To:	All plan holders	From:	Tracy Bruun, Division
Pages:	18 pages including this cover page	Phone:	515-344-6279
Re:	But901622D Nutrient Reduction Wetland (Bid 23-04)	Date:	September 17, 2023

Subject: **Addendum No. 1** to Bid Documents
But901622D - Nutrient Reduction Wetland Project – Bid No. 23-04
Butler County, Iowa

BUTLER COUNTY WETLAND PROJECT
BUT901622D - BID NO. 23-04
PREBID MEETING
September 12, 2023 - 9:15 AM

SHEET
C.01

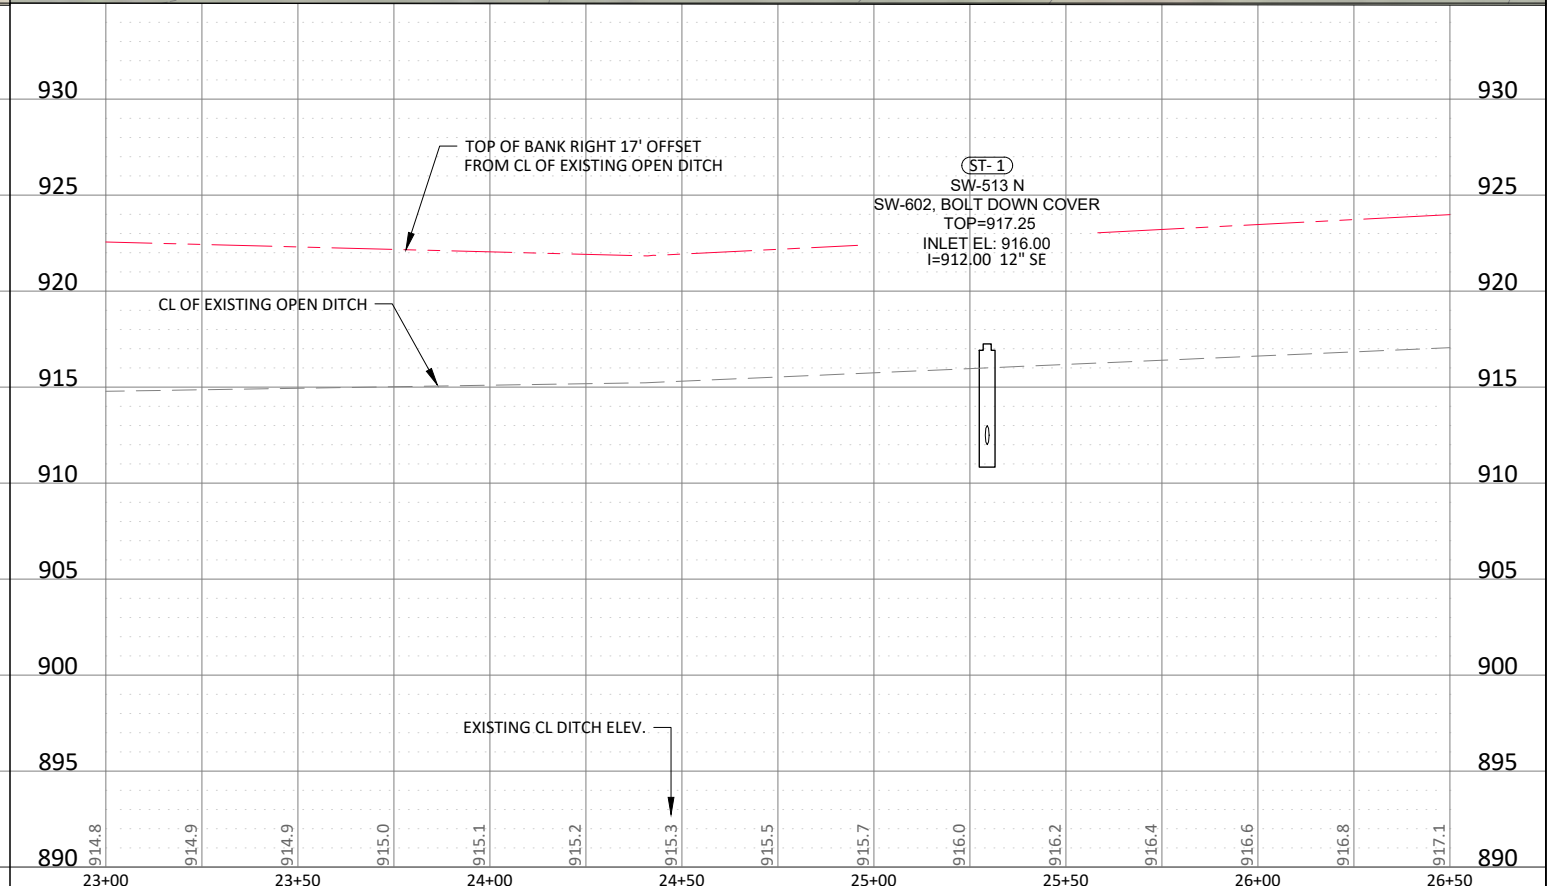
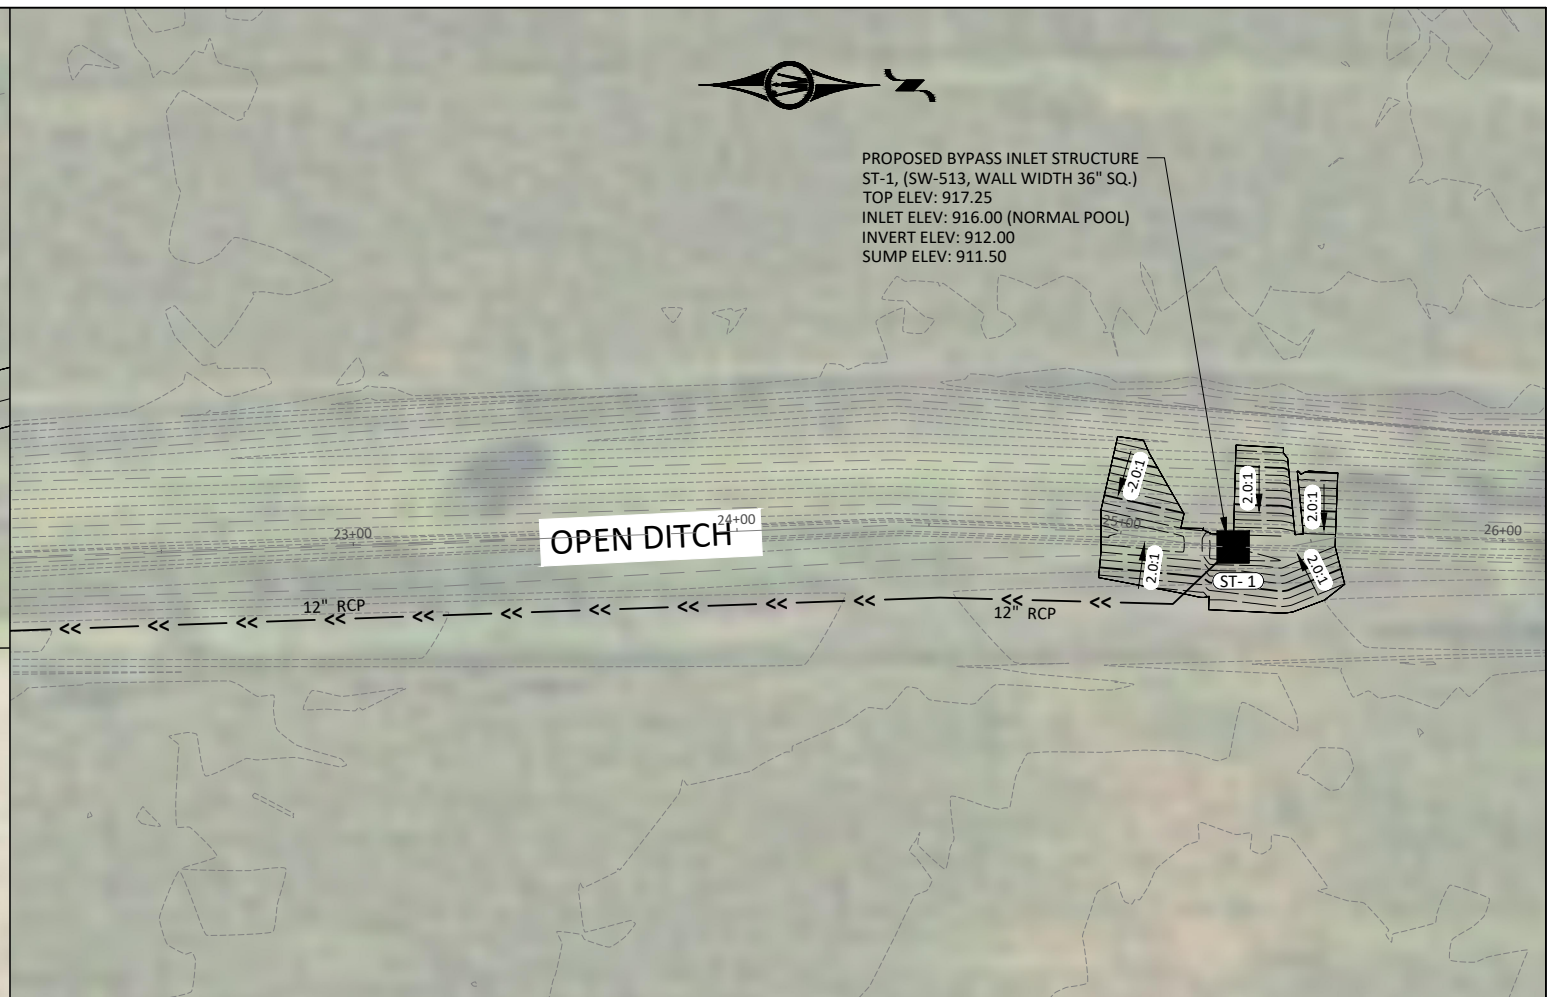
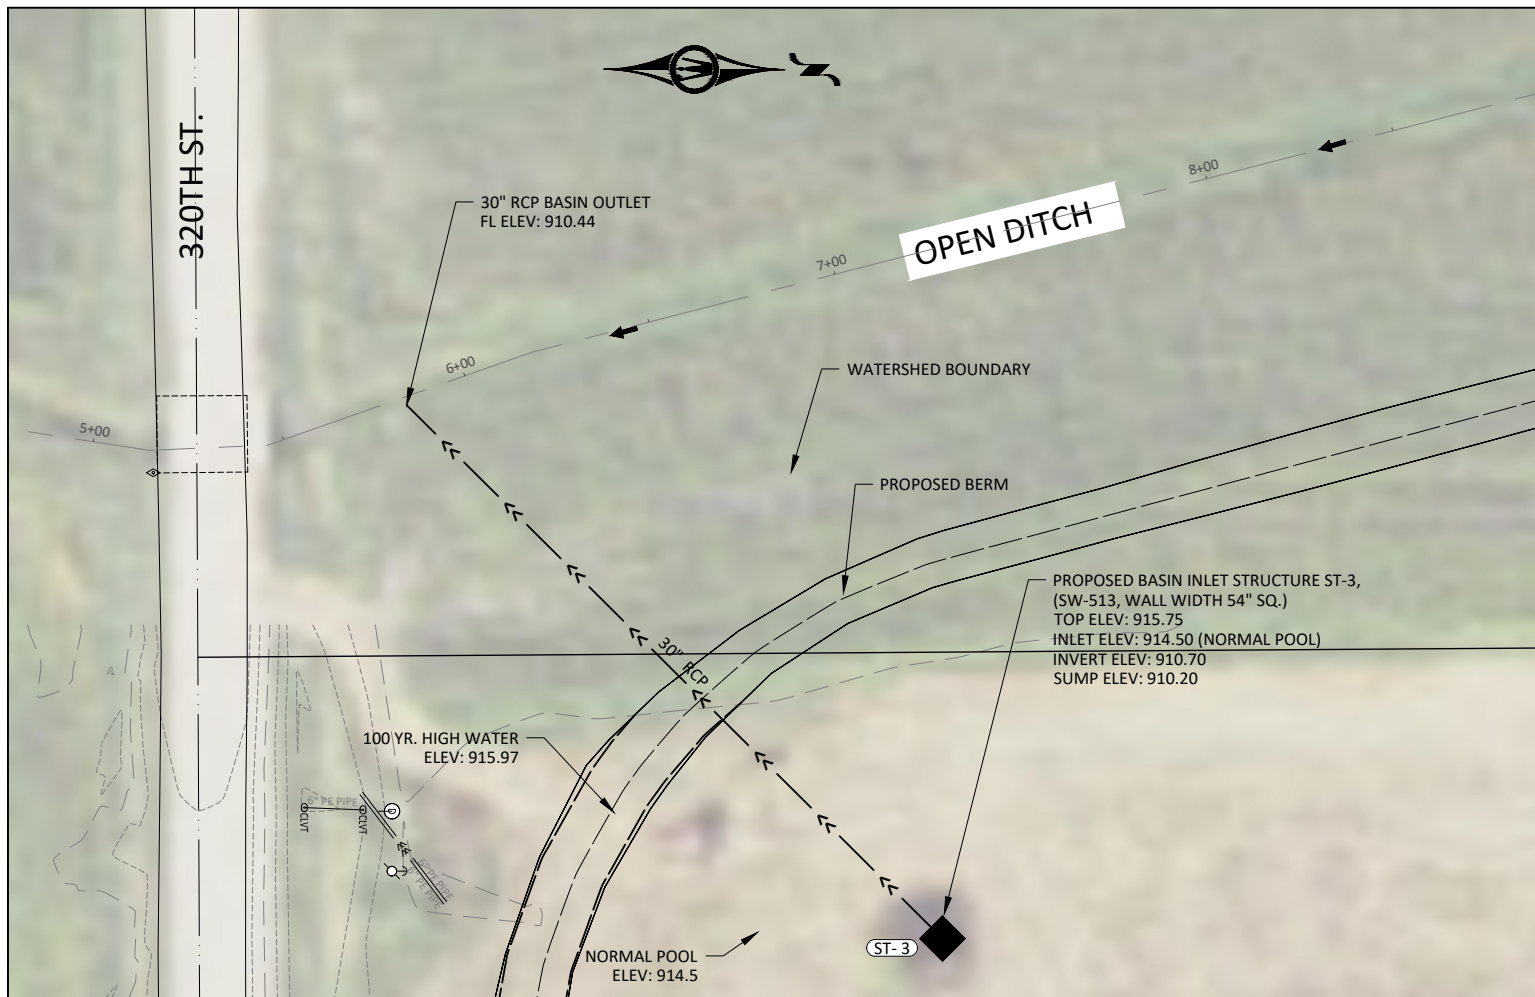
Plan Sheet C.01 – Updated Tables

SHEET
K.05

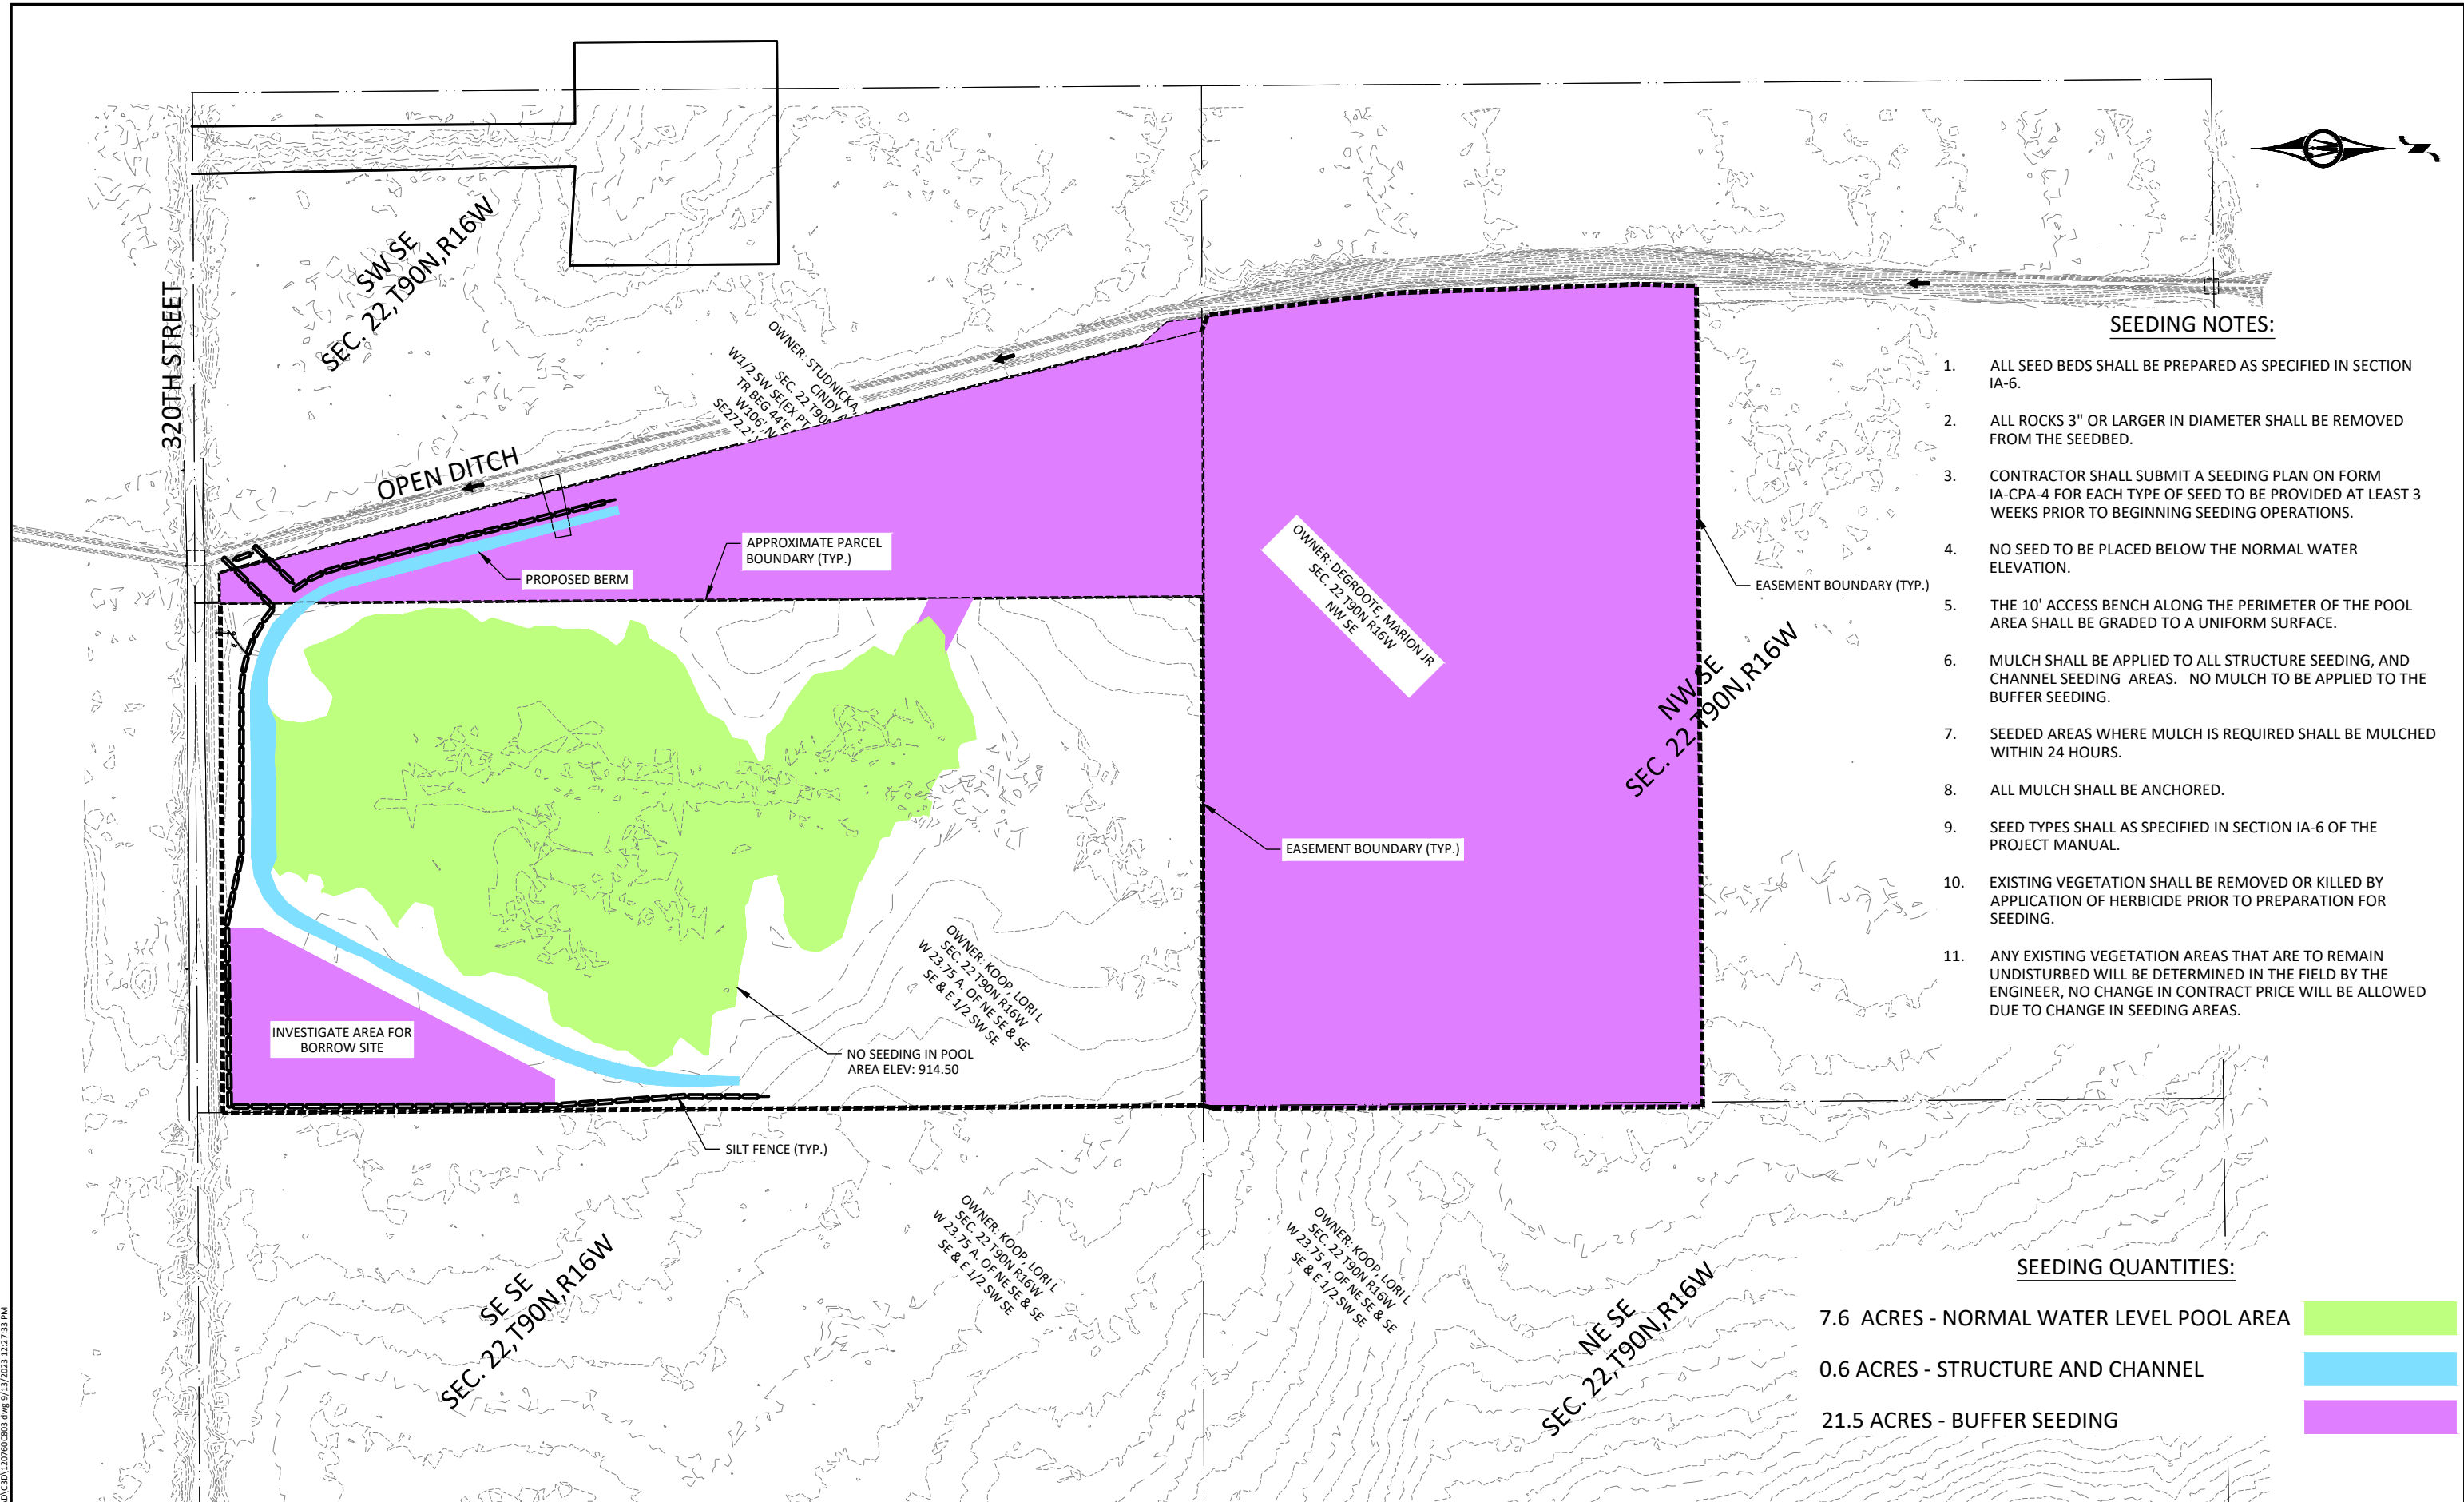
Plan Sheet K.05 – Updated seeding areas

- 7.6 ACRES - NORMAL WATER LEVEL POOL AREA
- 0.6 ACRES - STRUCTURE AND CHANNEL
- 21.5 ACRES - BUFFER SEEDING

FIGURE 3010.103 SHEET 1 OF 1

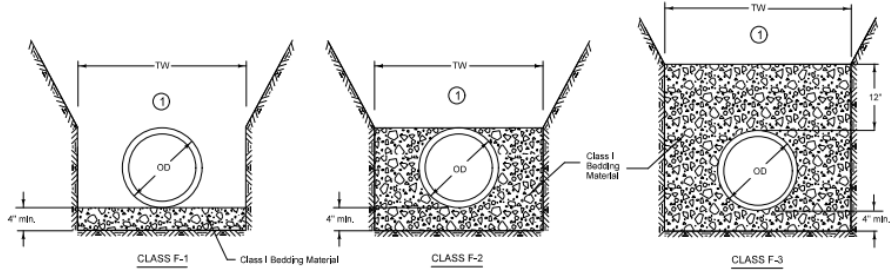
Q: Can HDPE Dual Wall or Polypropylene pipe be used as an alternative to RCP.

A: Yes, but the gaskets will have to soil tight and F-2 bedding (IDOT SW-103 provided below) using 1-inch clean crushed stone would be needed for bedding and would have to be included in the cost per foot of tile installed. Also, an appropriate apron with a footing will also be required as noted with Bid Items 14 and 15.
